## **O2 Masterplan Site**

Response to CBRE Interim ES Review Report

**August 2022**

Substituted Figure 13.6

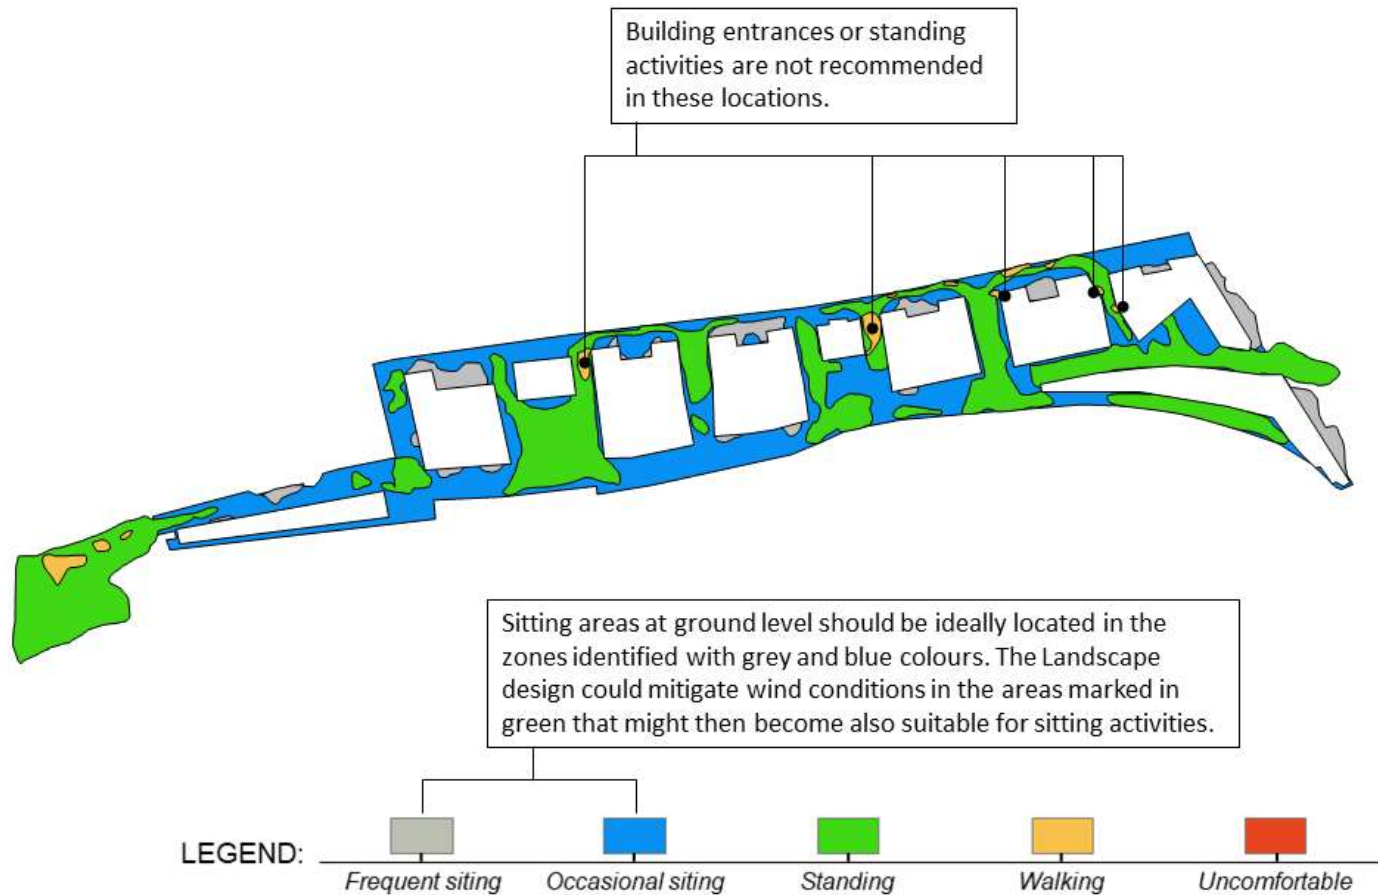
- 17.1.1 (a) The CFD results for the baseline scenario are shown in Figures 13.5 and 13.6. The resolution of the image is poor, as is the case with all the images presented in this chapter, and the red line boundary is not indicated so it is difficult to establish which receptor points fall within the site and which fall outside it. This differentiation is important as the proposed development impact assessment methodology for locations outside the site includes a consideration of any changes in wind conditions from the baseline. It is requested that the Applicant provides better-quality images, including the red line boundary so that it is clearly indicated what the baseline results are for all receptor points outside the site boundary.

17.3.1 (a) The Figures below substitute Figures 13.5 and Fig 13.6 in the Chapter 13 Wind Microclimate report, to address higher resolution issues and the lack of the site boundary red line. We have also provided as a separate Appendix (8a) for clarity. It is also confirmed that all receptors analysed in these two Figures are at ground level.
